NORTH ELEVATION
"FRONT"

691 W CANFIELD

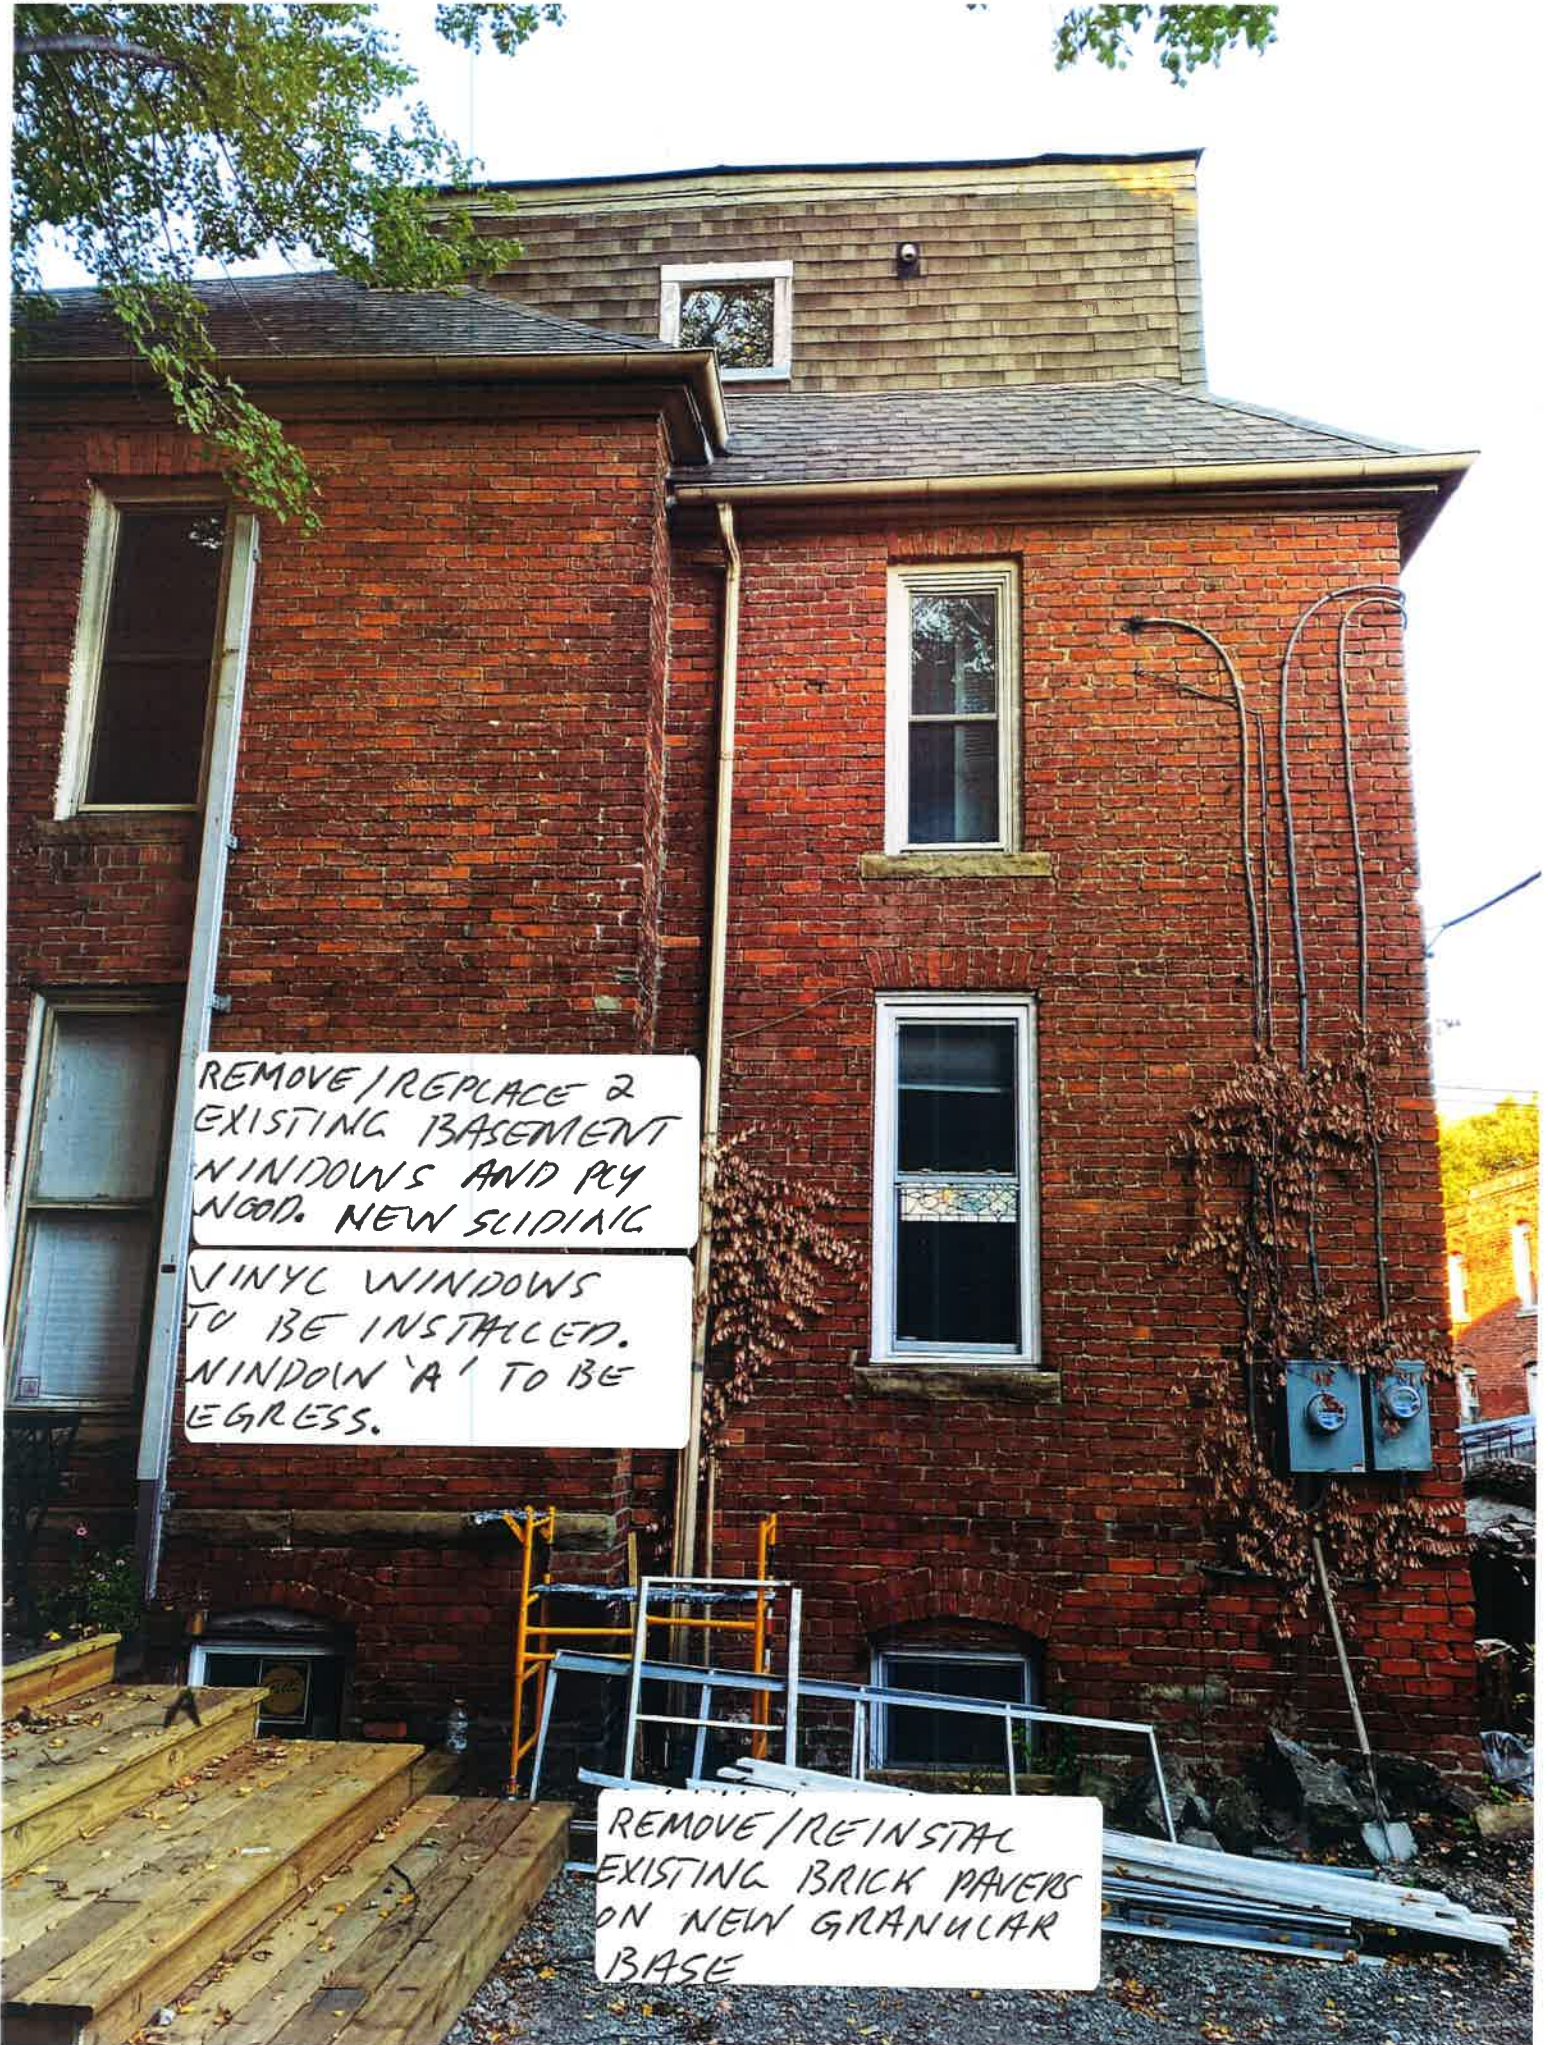
REMOVE EXISTING MOSS COVERED ASPHALT ROOF SHINGLES ON PORCH. REPLACE WITH NEW ASPHALT SHINGLES TO MATCH UPPER ROOF

REMOVE EXISTING SLIDING VINYL BASEMENT WINDOW LOWER SILL 10" AND PROVIDE NEW SINGLE HUNG VINYL EGRESS WINDOW

PROVIDE 6X6 PTW WINDOW WELL TO SUIT. REPLACE EXISTING WOOD TRIM TO MATCH.

6' METAL PICKET FENCE TO CLOSE OFF EAST SIDE YARD. GATED FOR ACCESS

SOUTH ELEVATION
1 OF 3

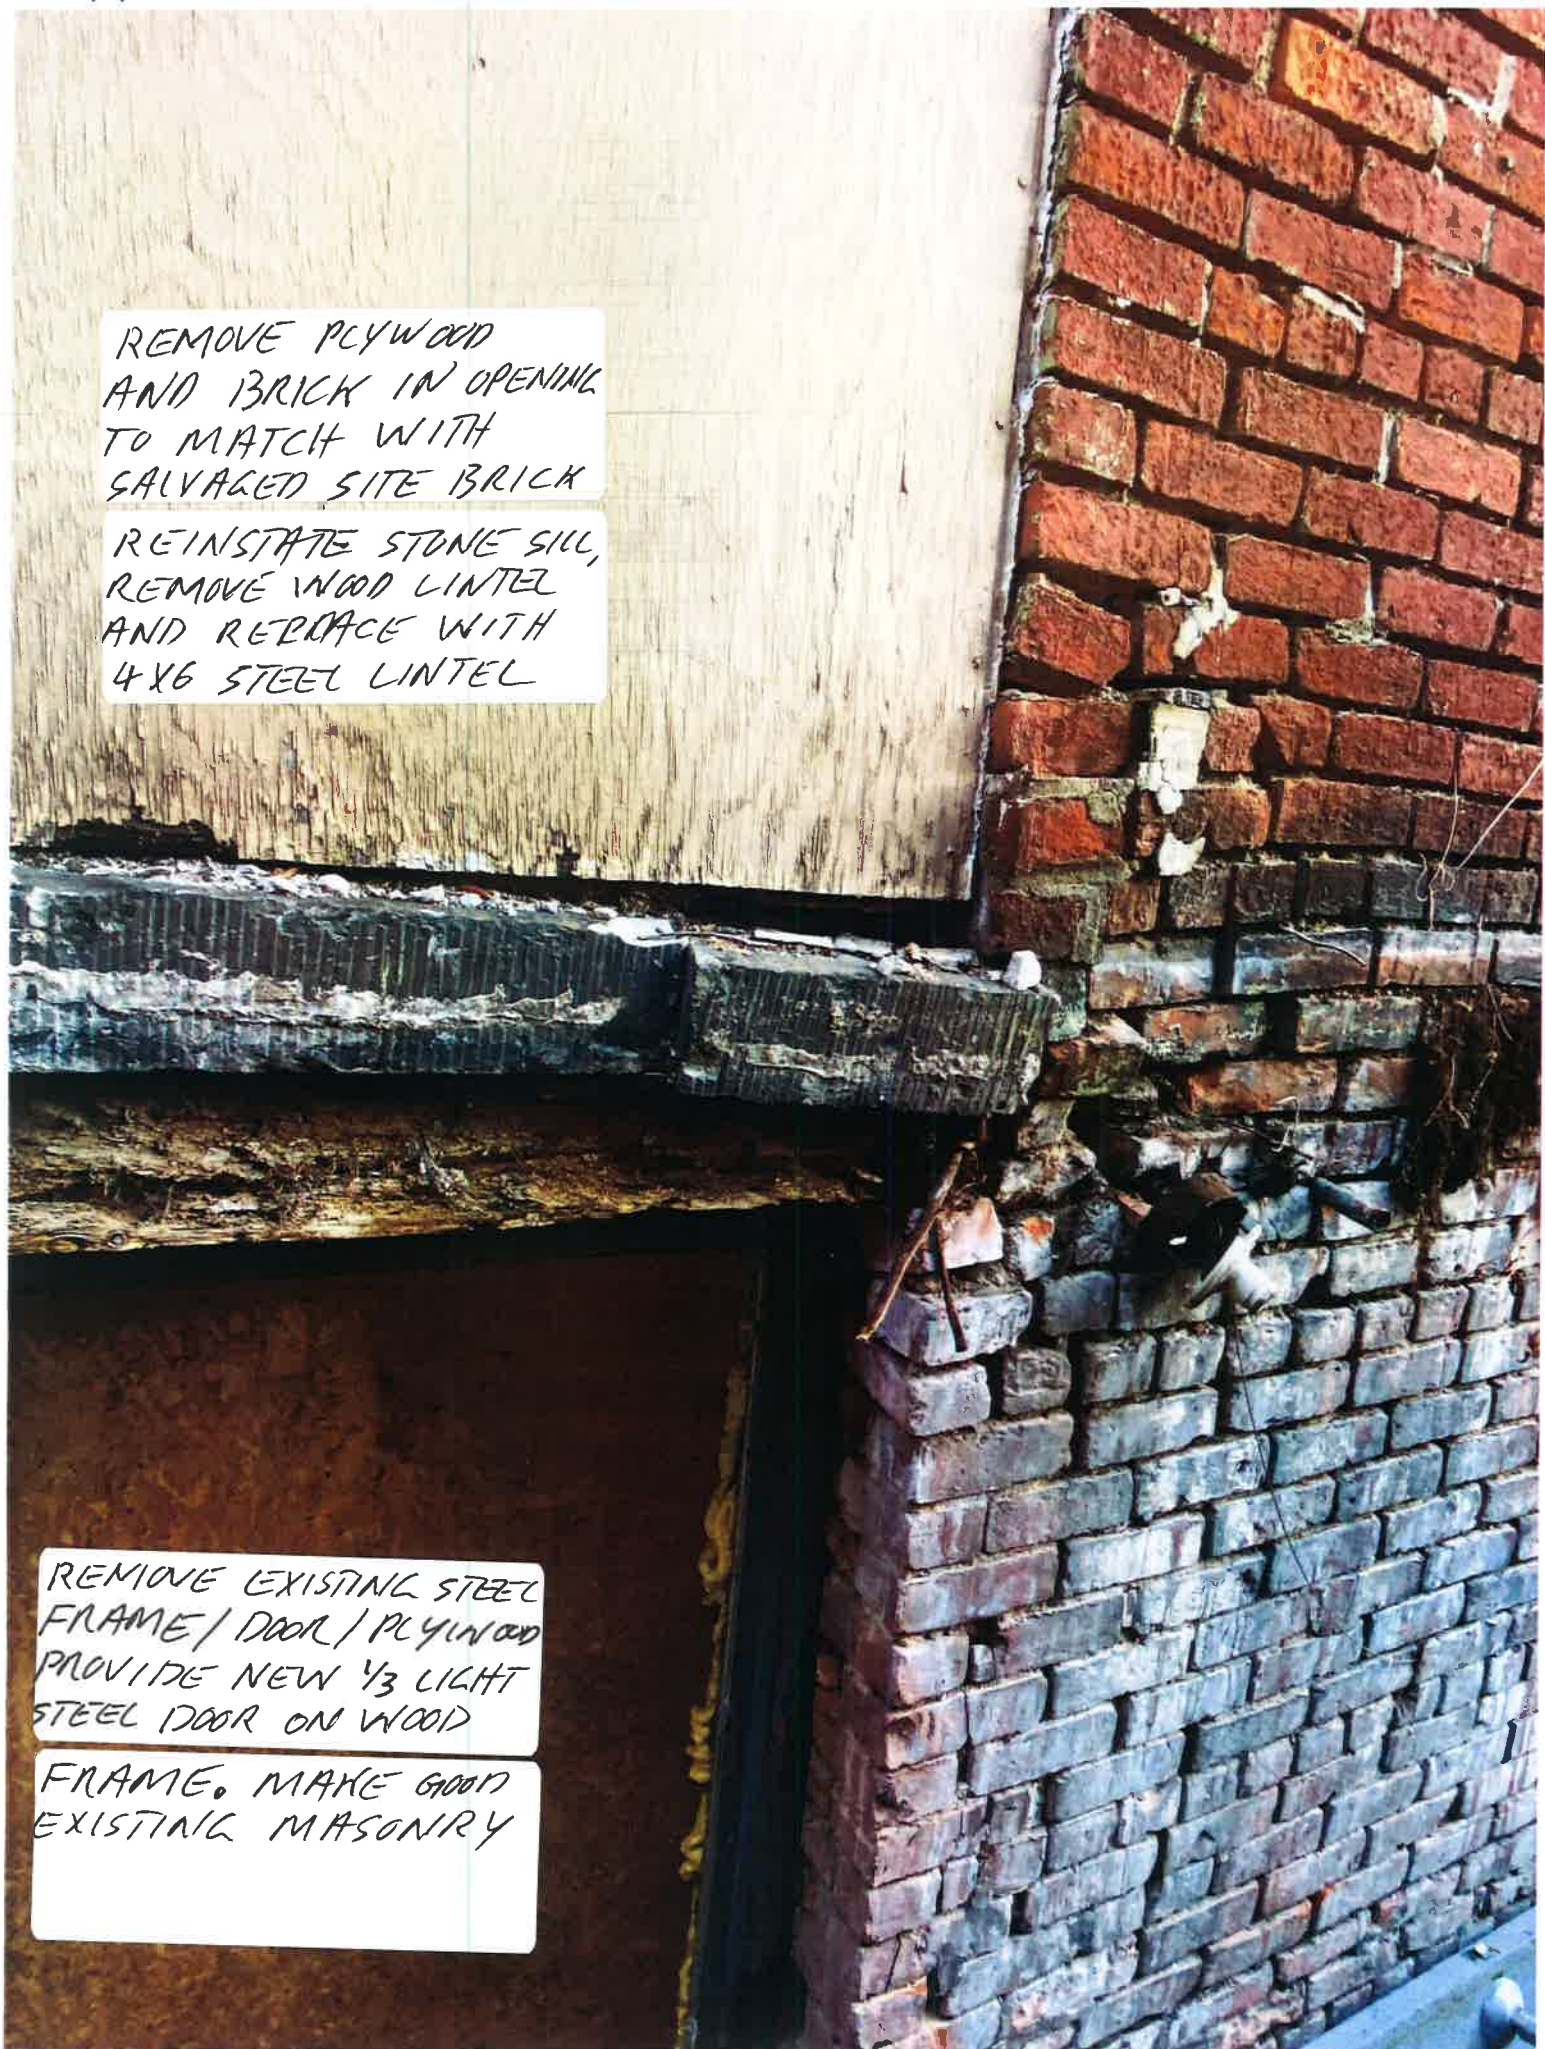
REMOVE/REPLACE 2
EXISTING BASEMENT
WINDOWS AND PLY
WOOD. NEW SLIDING

VINYL WINDOWS
TO BE INSTALLED.
WINDOW 'A' TO BE
EGRESS.

REMOVE/REINSTALL
EXISTING BRICK PAVERS
ON NEW GRANULAR
BASE

REMOVE PLYWOOD AT
DOOR AND WINDOW.
INFILL WITH EXISTING
SALVAGED BRICK
FROM THE SITE

EXISTING CONCRETE
STAIRS AND RUBBLE
STRUCTURE TO BE
STABILIZED AND REMAIN

EAST ELEVATION 1 OF 2

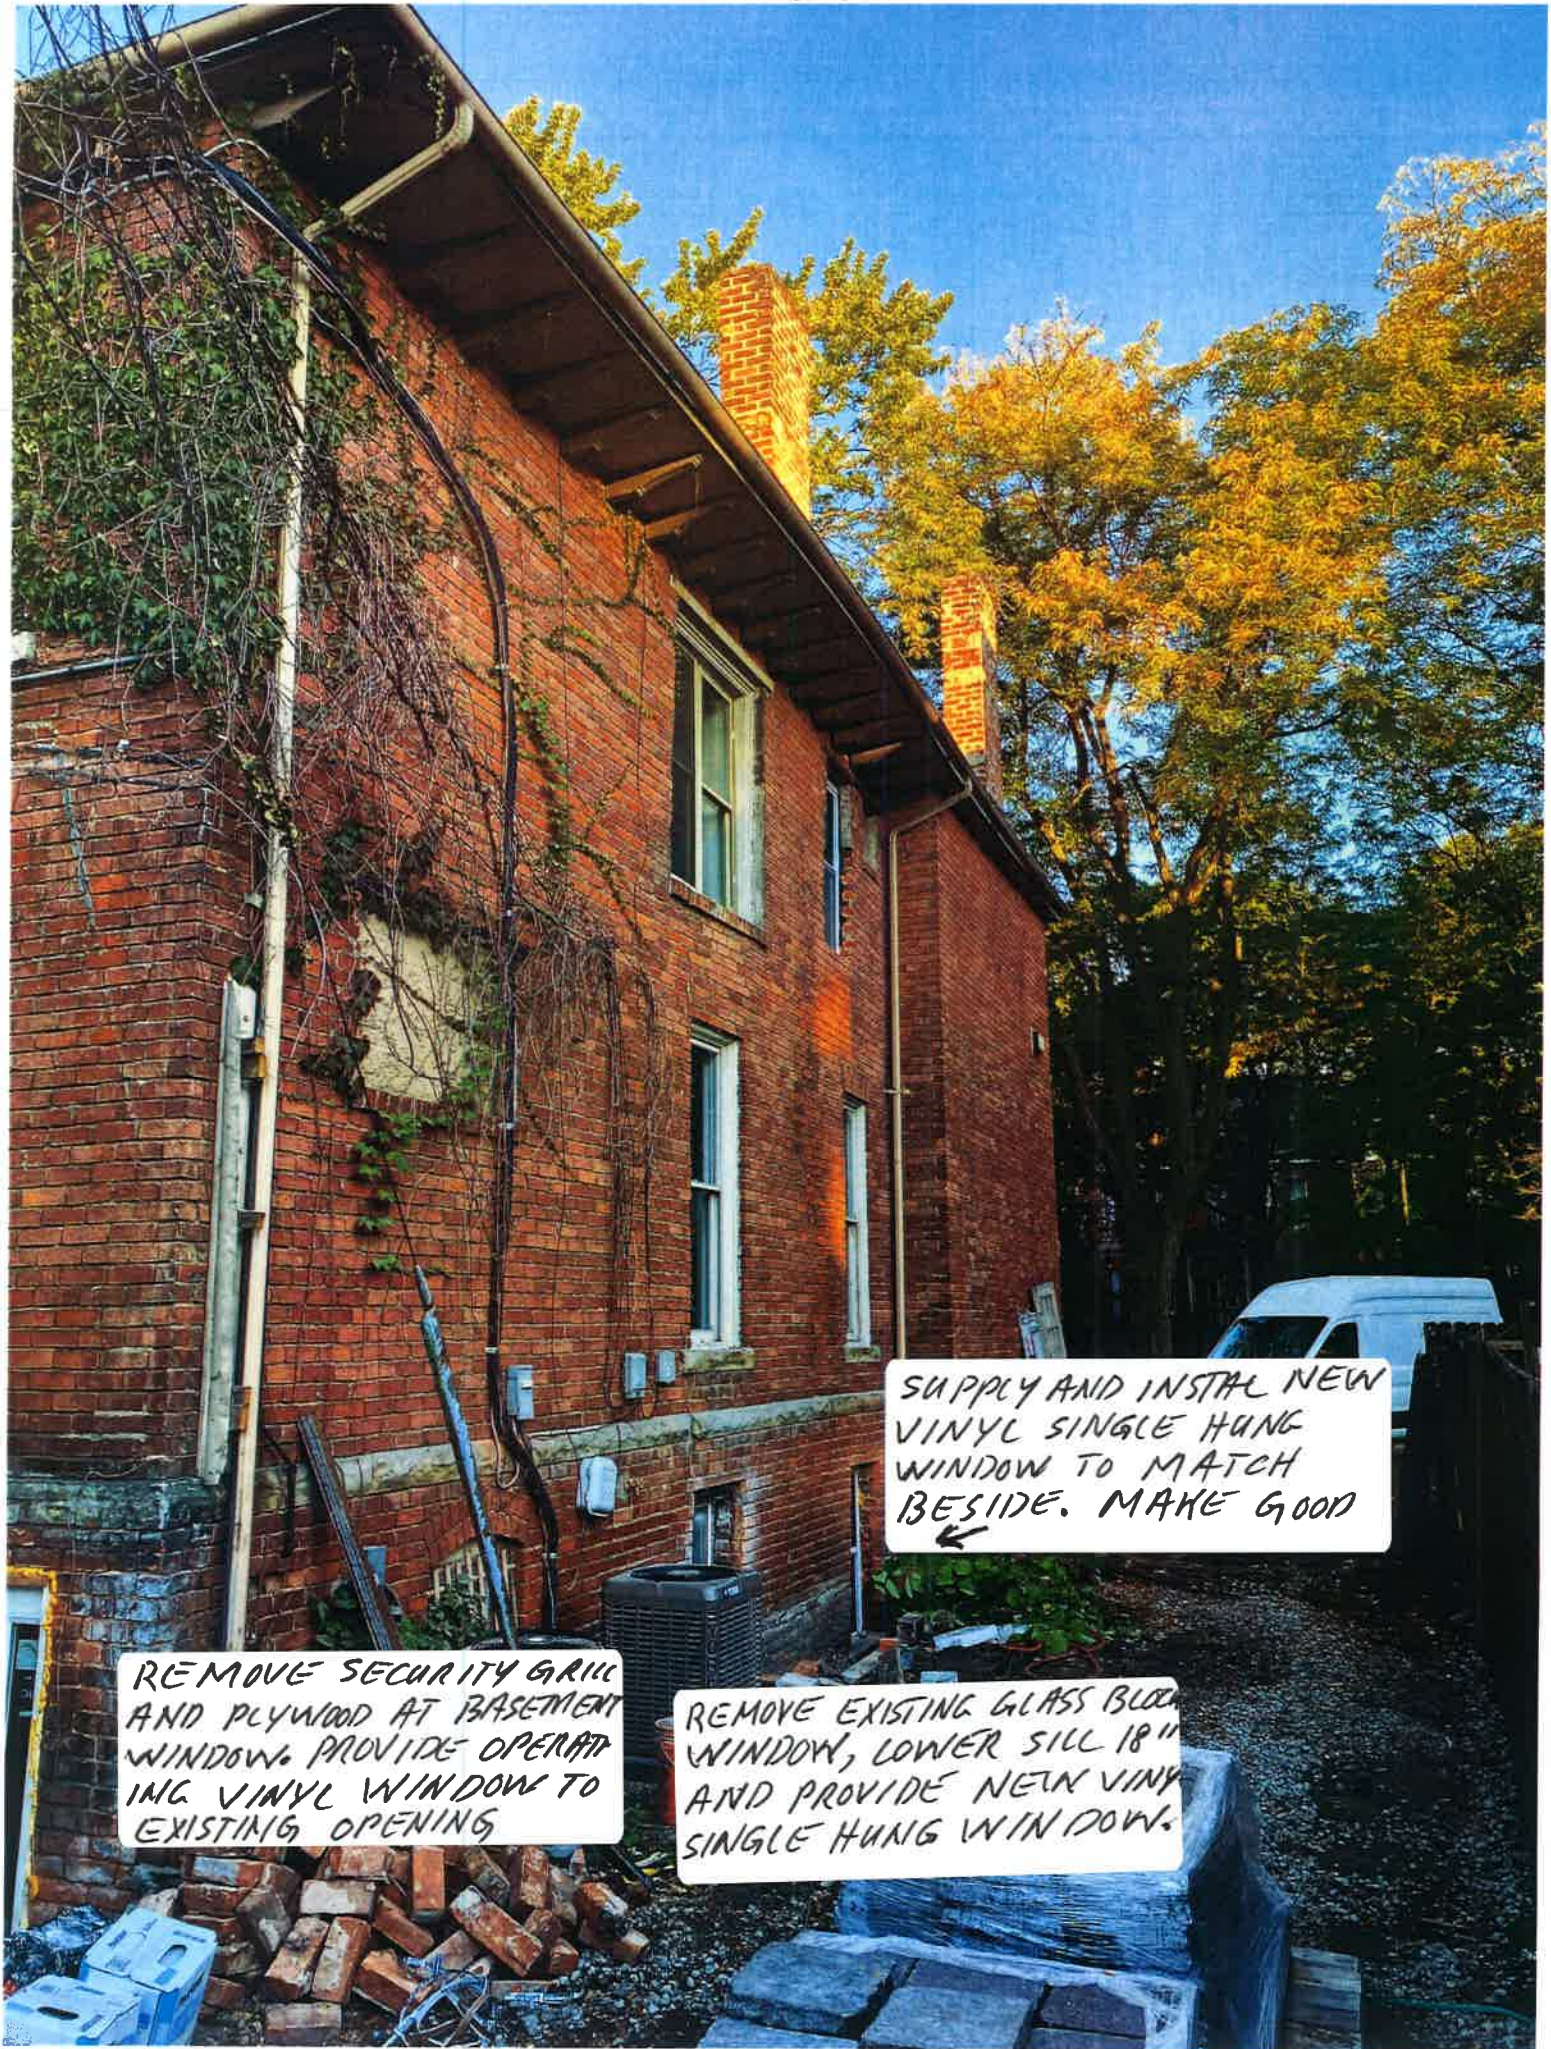
REMOVE PLYWOOD
AND BRICK IN OPENING
TO MATCH WITH
SALVAGED SITE BRICK

REINSTATE STONE SILL,
REMOVE WOOD LINTEL
AND REPLACE WITH
4X6 STEEL LINTEL

REMOVE EXISTING STEEL
FRAME / DOOR / PLYWOOD
PROVIDE NEW 1/3 LIGHT
STEEL DOOR ON WOOD

FRAME. MAKE GOOD
EXISTING MASONRY

REMOVE PLYWOOD AND
BRICK IN RIGHT SIDE
WINDOW TO MATCH.
EXTEND LEFT WINDOW

SILL DOWN 18" AND
PROVIDE VINYL SINGLE
HUNG WINDOW. MAKE
GOOD MASONRY OPENING
